Default Aimpoint Offset Revision for ACIS-S and ACIS-I

Chandra X-Ray Observatory

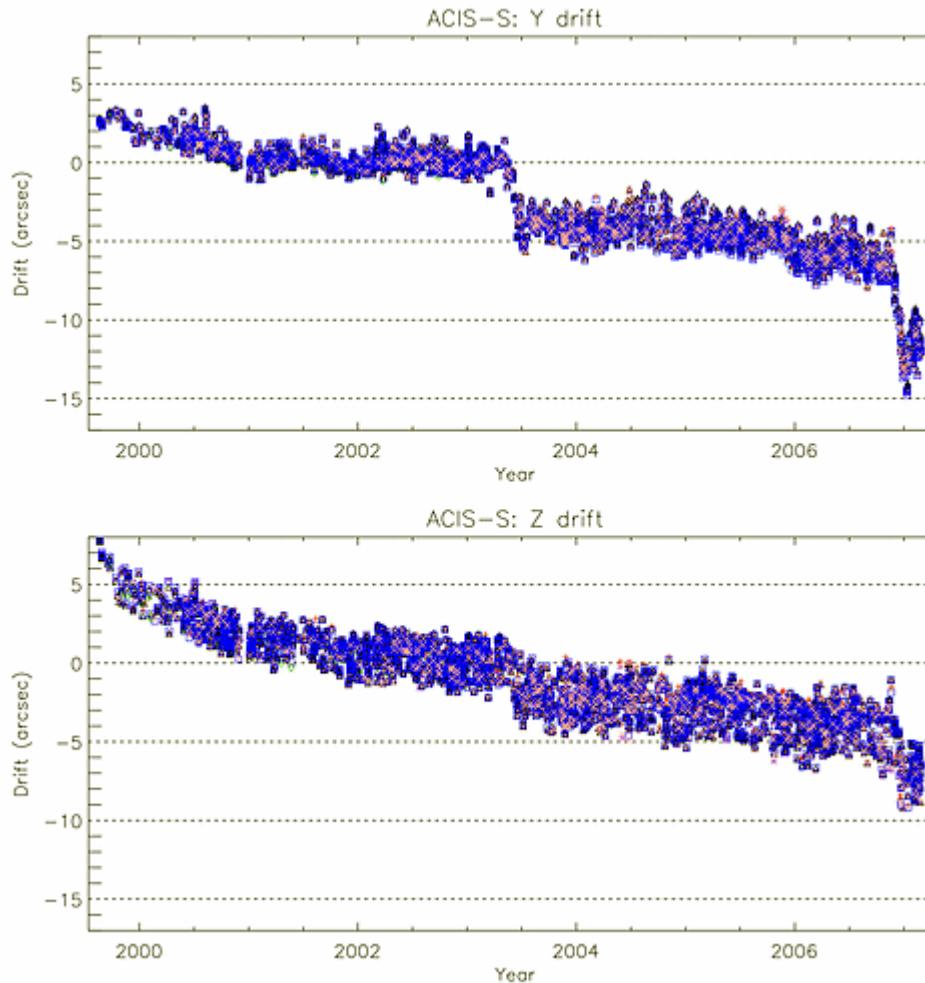
- Since 2005 the Aspect Camera alignment has shifted about 10''
 - Long-term alignment drift in spacecraft (continued heating)
 - Alignment shift of ACA after cooling ACA CCD from -15C to -19C
- This translates into an aimpoint drift
- To place the aimpoint so targets are at the optimal positions with respect to CHIP geometry and telescope focus, default aimpoint offsets for ACIS-S and ACIS-I have been revised.

Y	Z

ACIS-S	0	-0.25'
ACIS-I	-0.2'	-0.25'

- Effective 19-Feb-2007, all Cycle 9 and remaining Cycle 8 observations requesting default offsets will be made using the new default values.
